PROJECT # 9918

City of Coos Bay Plan Review APPROVED As submitted Per correction letter 12-17-99

5113 PORTLAND ROAD N.E. Salem, Oregon 97303 (800) 745-3406	
Customer:		FAMILIAN NORTHWEST	
End User:		FAMILIAN NORTHWEST	
Location:		COOS BAY, OR	
Det. By	Chk By	Date	Scale
TIS		10-19-1999	N.T.S.
Building ID	Job Number	Sheet Number	Issue
A	0801-183342	F1 of 2	0

SITE PLAN
SCALE: 1"=20'

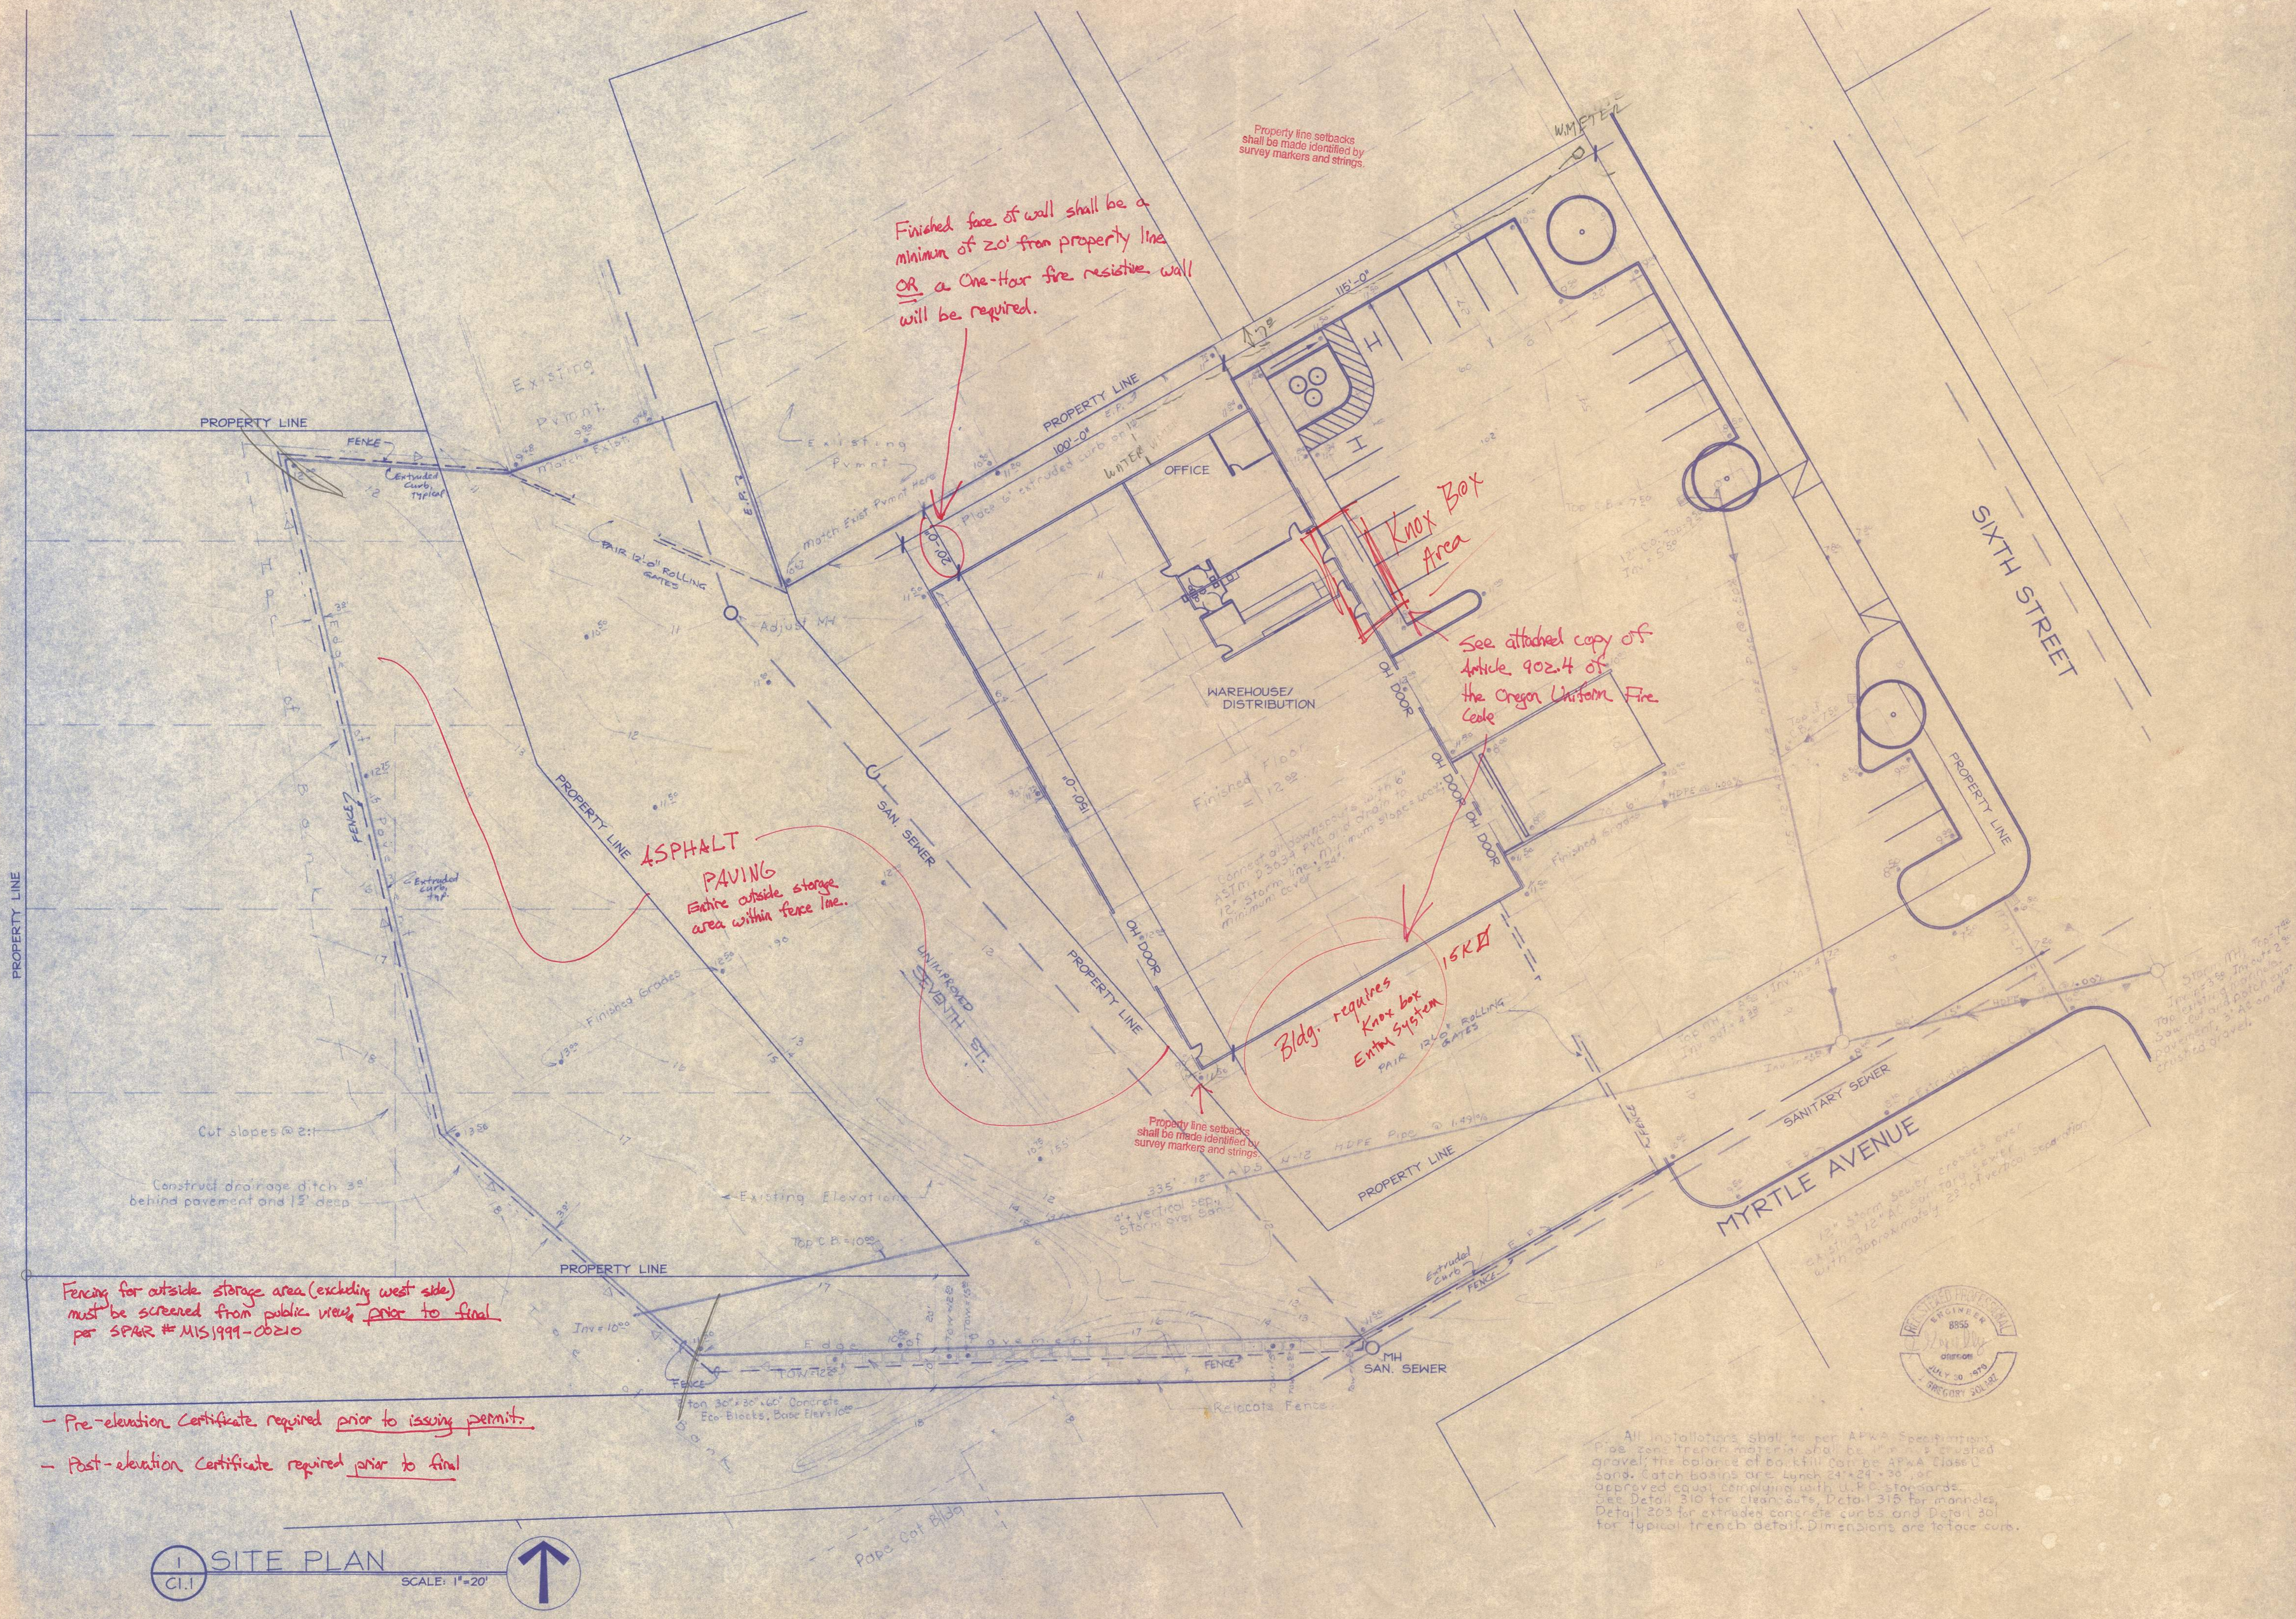
Fencing for outside storage area (excluding west side) must be screened from public view, prior to final per SPAR # MIS1991-0210

- Pre-elevation Certificate required prior to issuing permits.
- Post-elevation Certificate required prior to final

1 FLOOR PLAN
AI.1
SCALE: 3/16" = 1'-0"
→

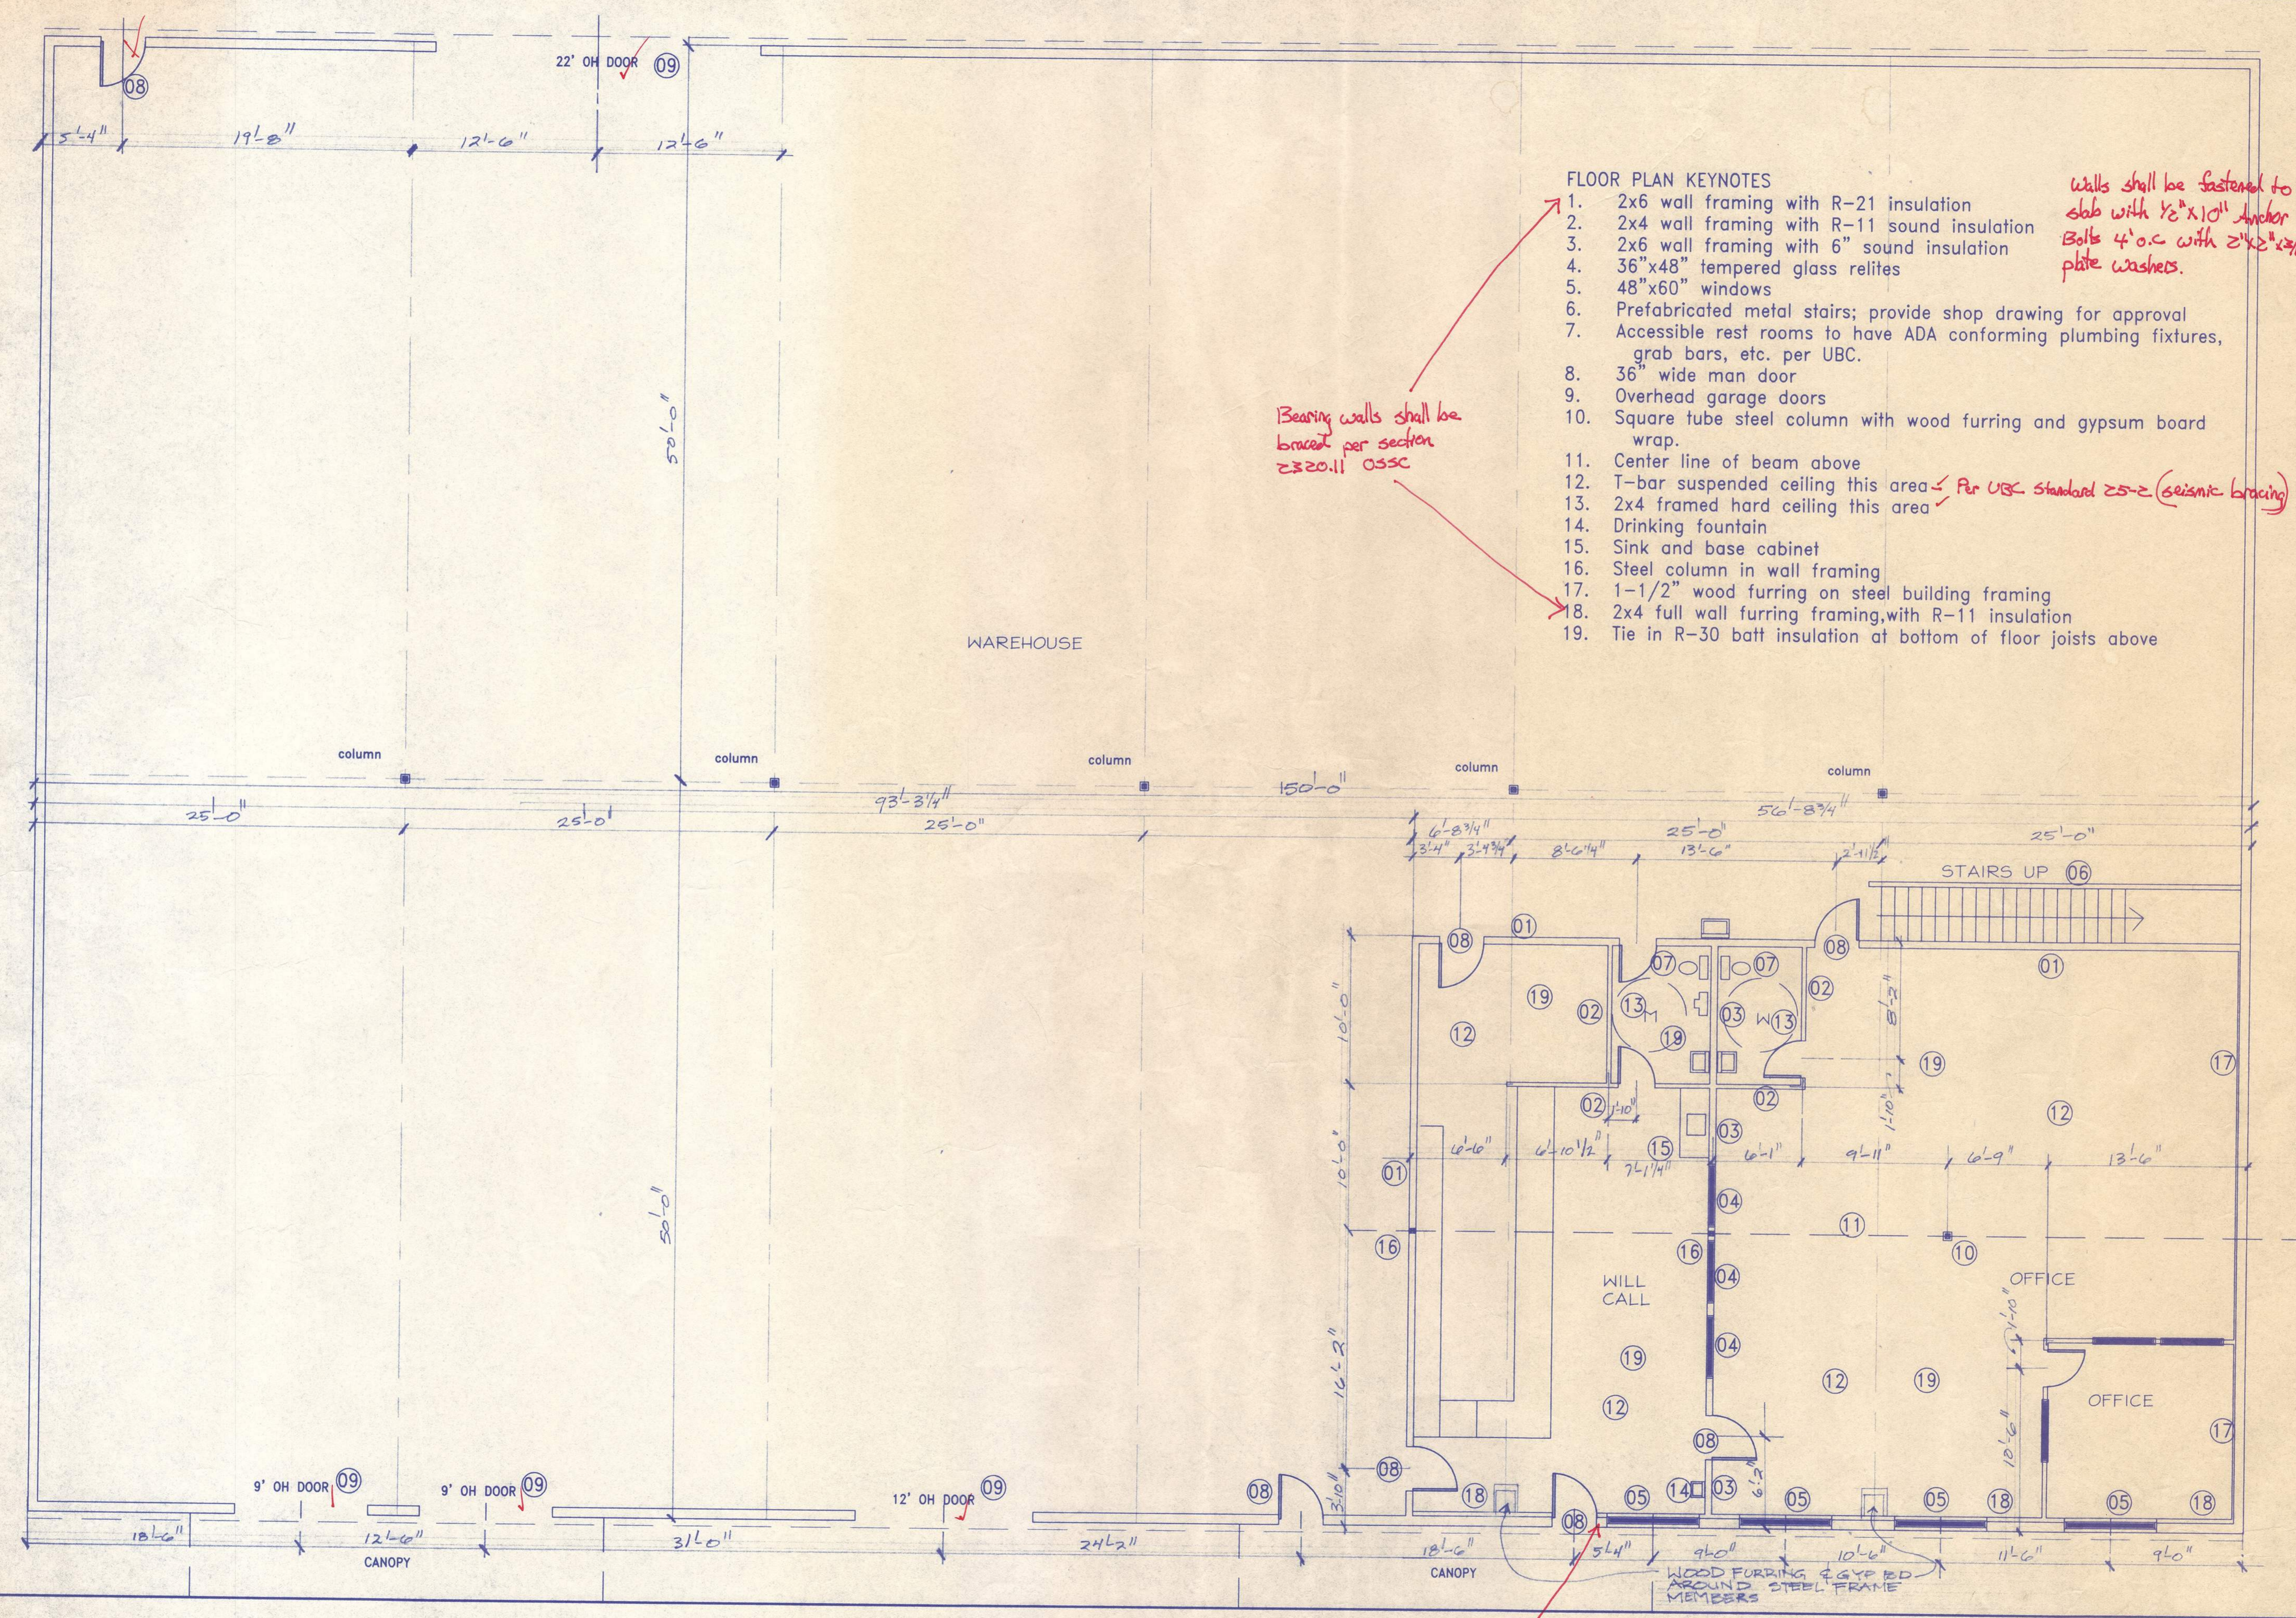
Walls shall be fastened to slab with 1/2"x10" anchor bolts 4' o.c. with 2"x2"x3/16" plate washers.

Bearing walls shall be braced per section 2320.11 OSSC

Windows within 24" of door are required to be tempered.

LOADING DOCK WALL ELEVATION

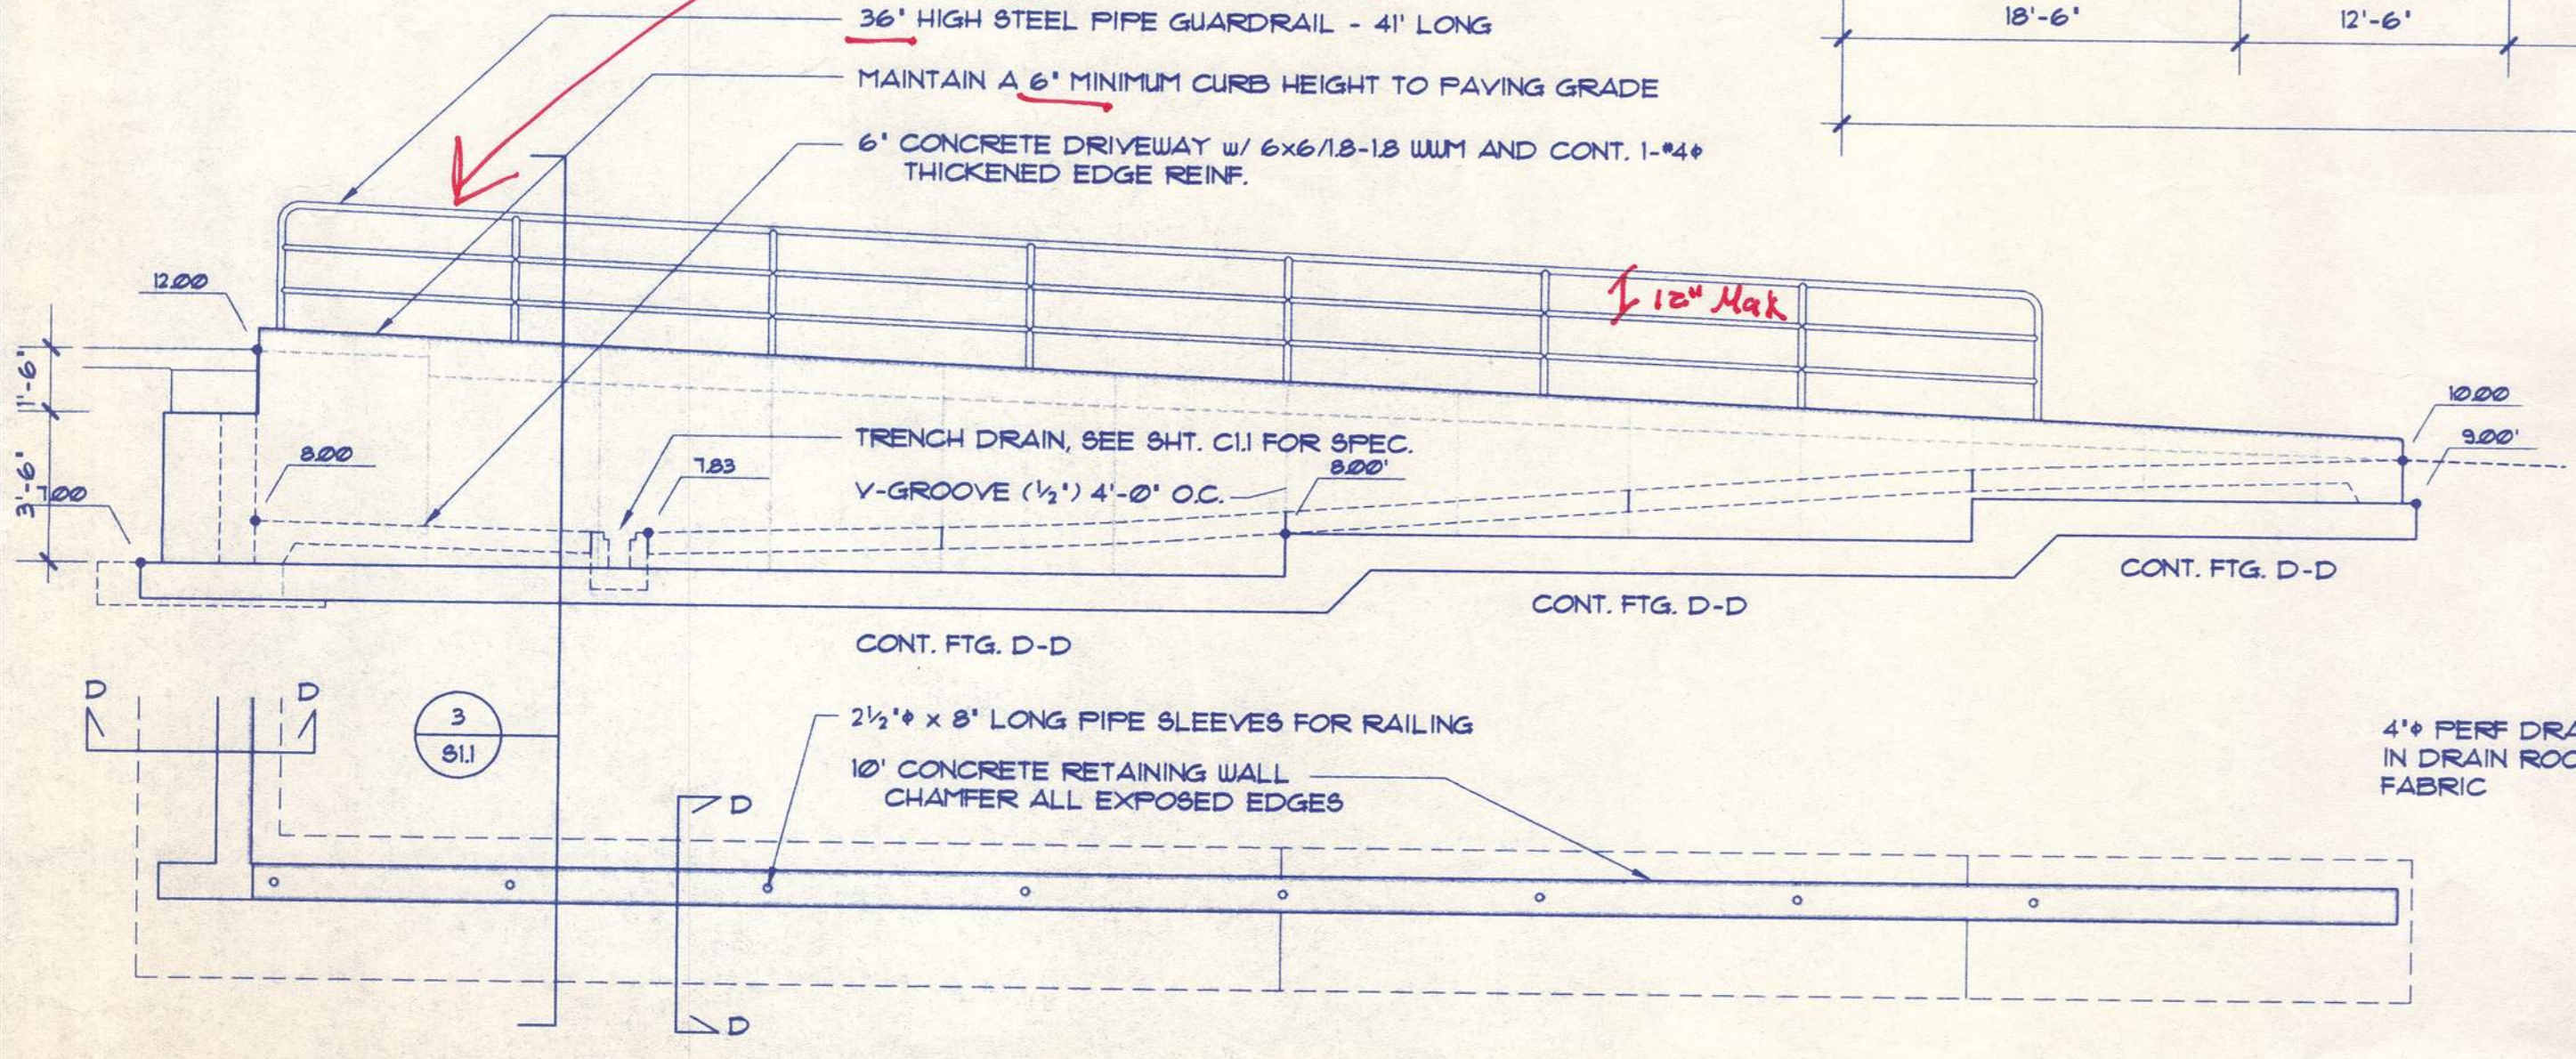
Guardrail shall be a minimum of 42" high above adjacent grade.
